DRAINAGE LETTER

5819 PALMER PARK BLVD.

PART OF LOT 1, POWERS CENTER, FILING NO. 3

Revised
November 23, 2018

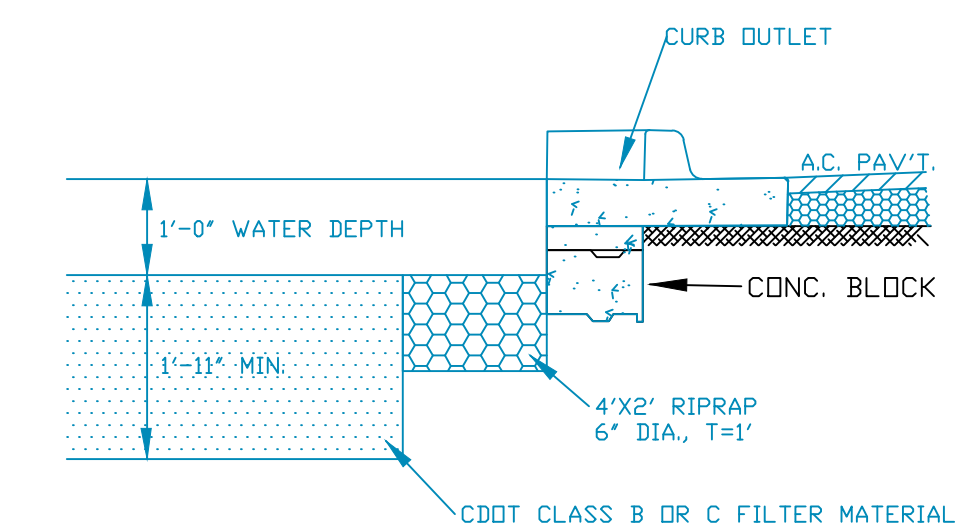
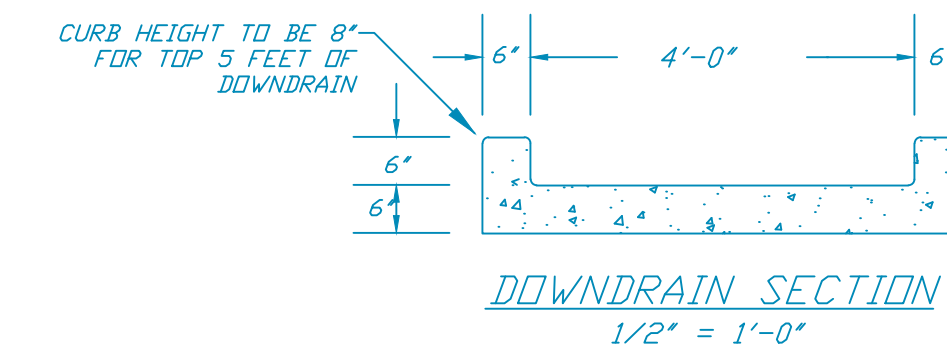
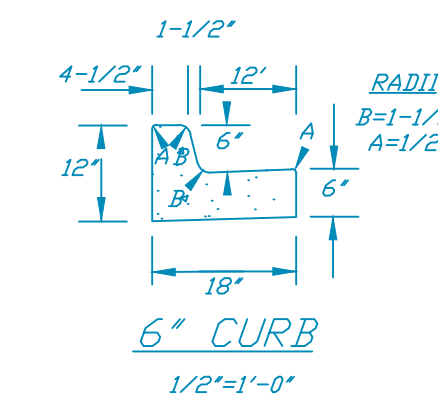
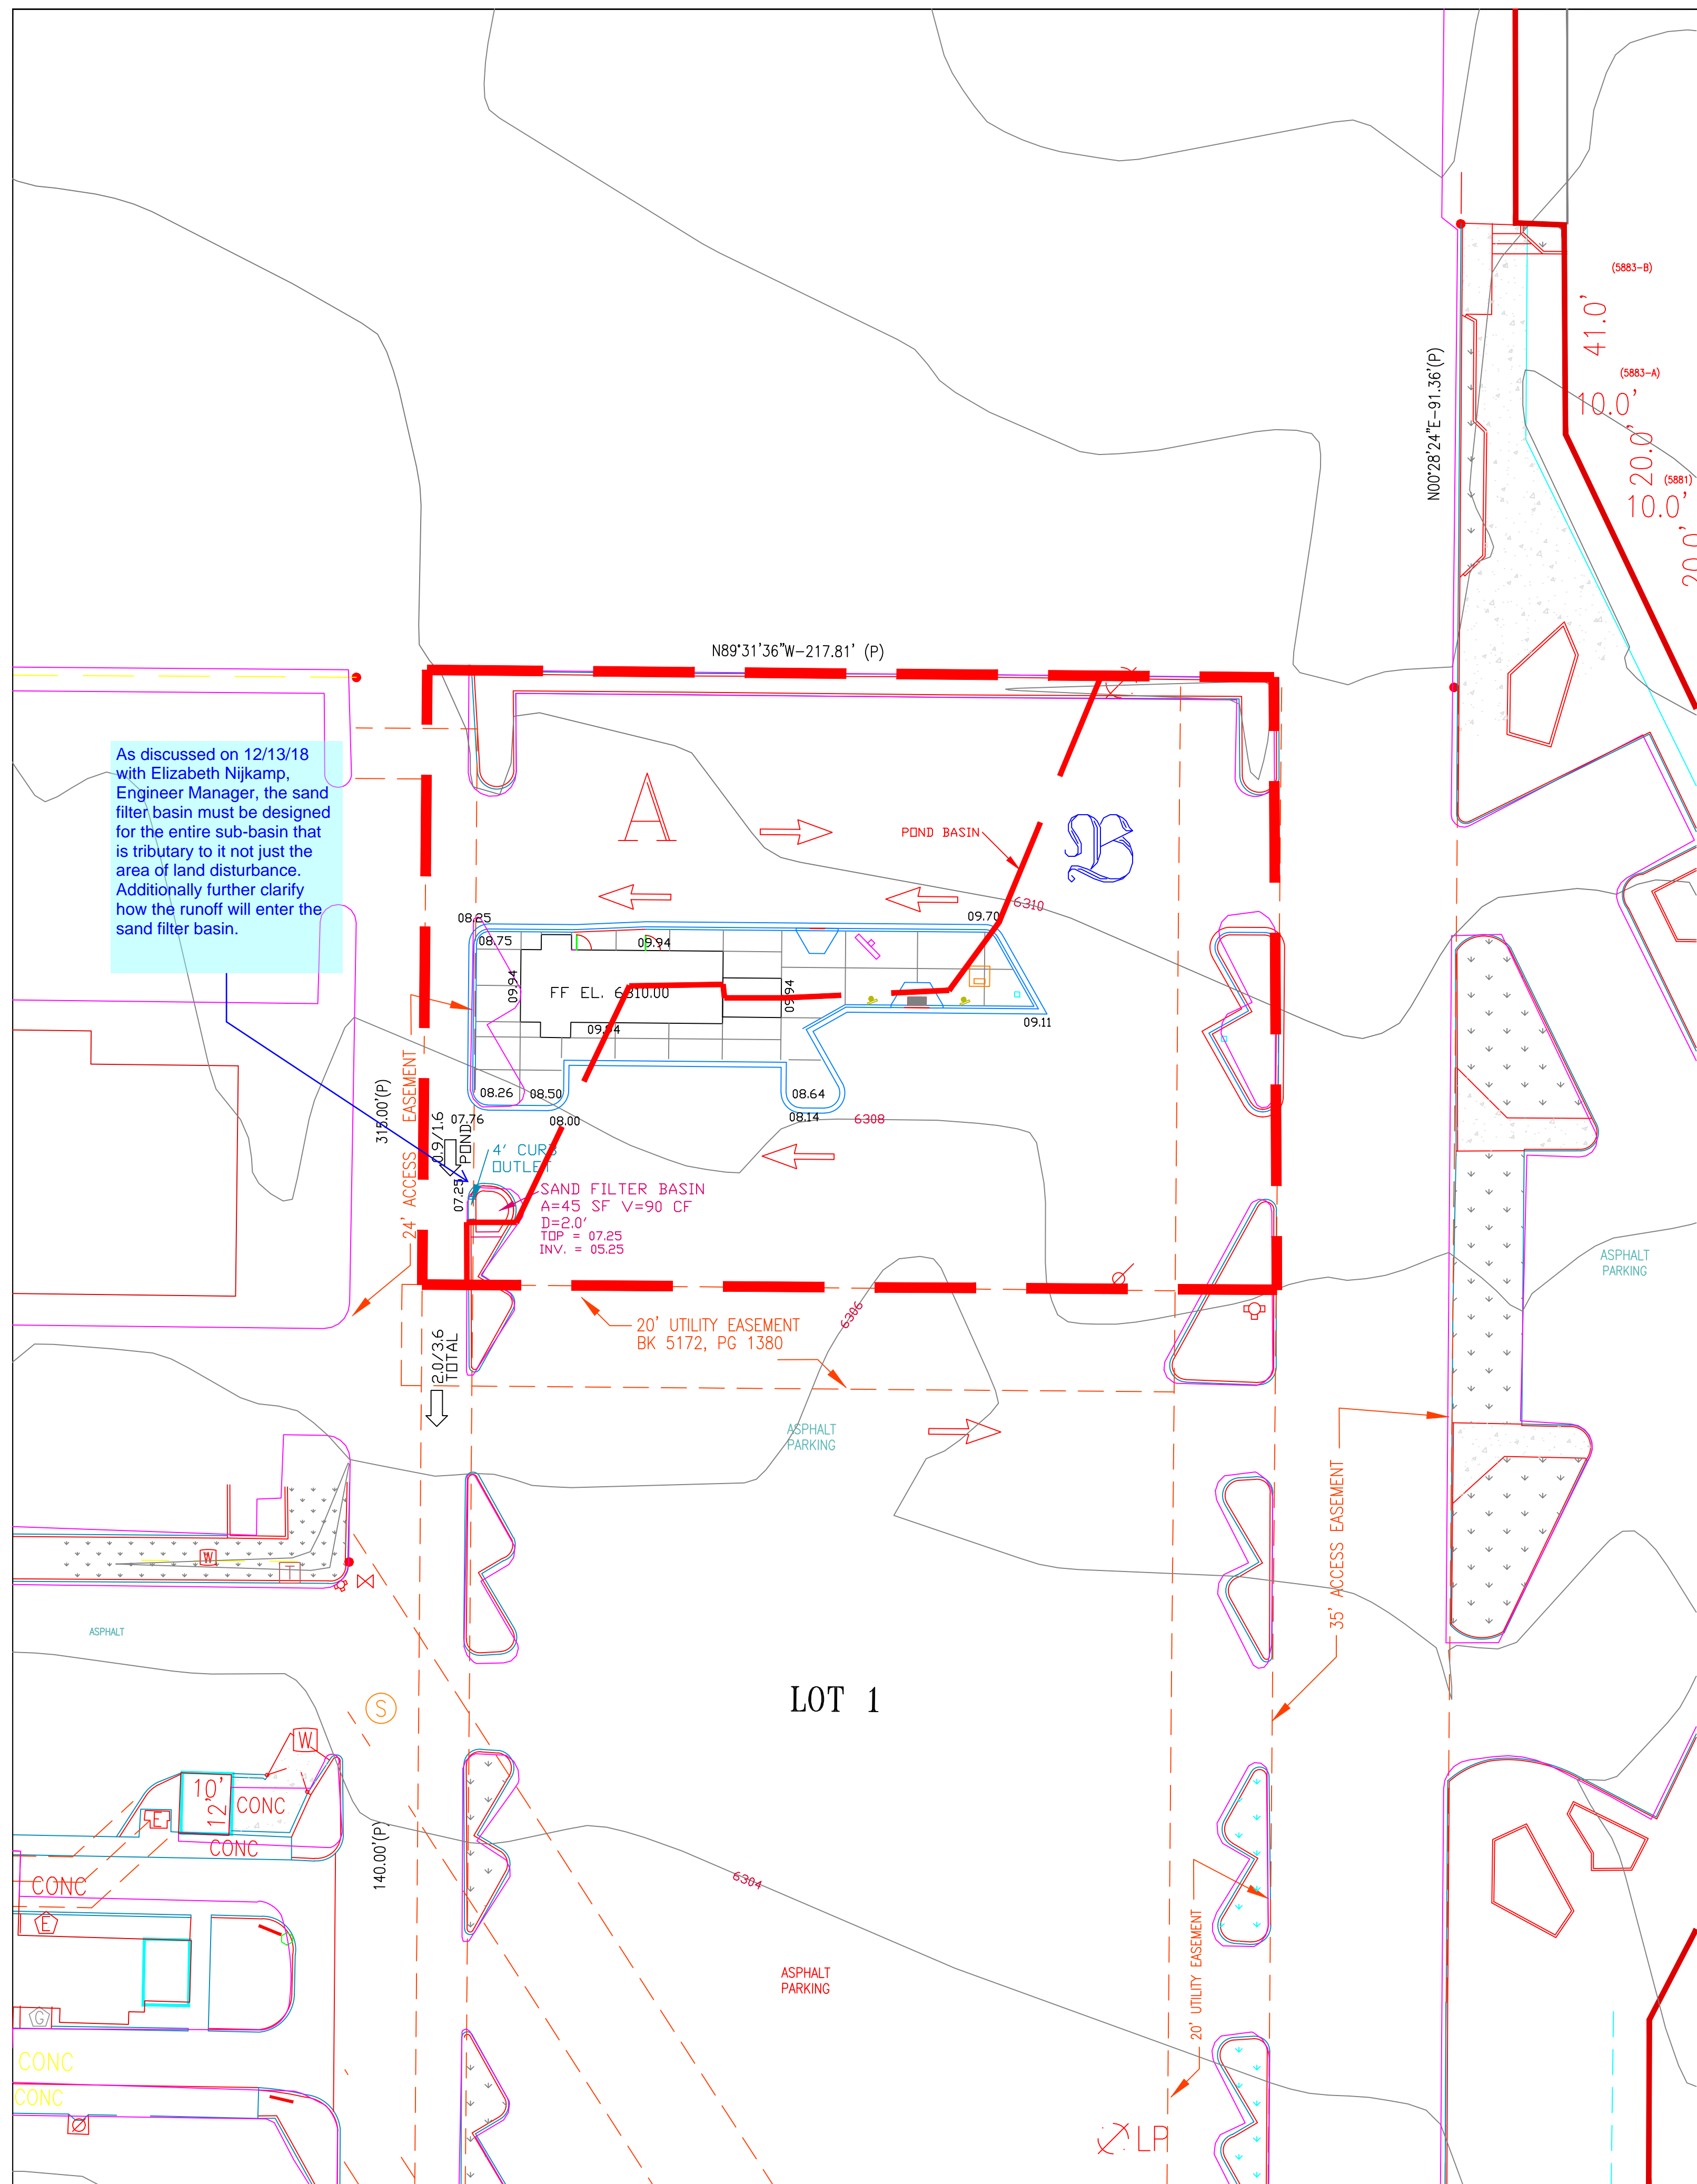
As discussed on 12/13/18 with Elizabeth
Nijkamp, Engineer Manager, the sand
filter basin must be designed for the entire
sub-basin that is tributary to it not just the
area of land disturbance. Additionally
further clarify how the runoff will enter the
sand filter basin.
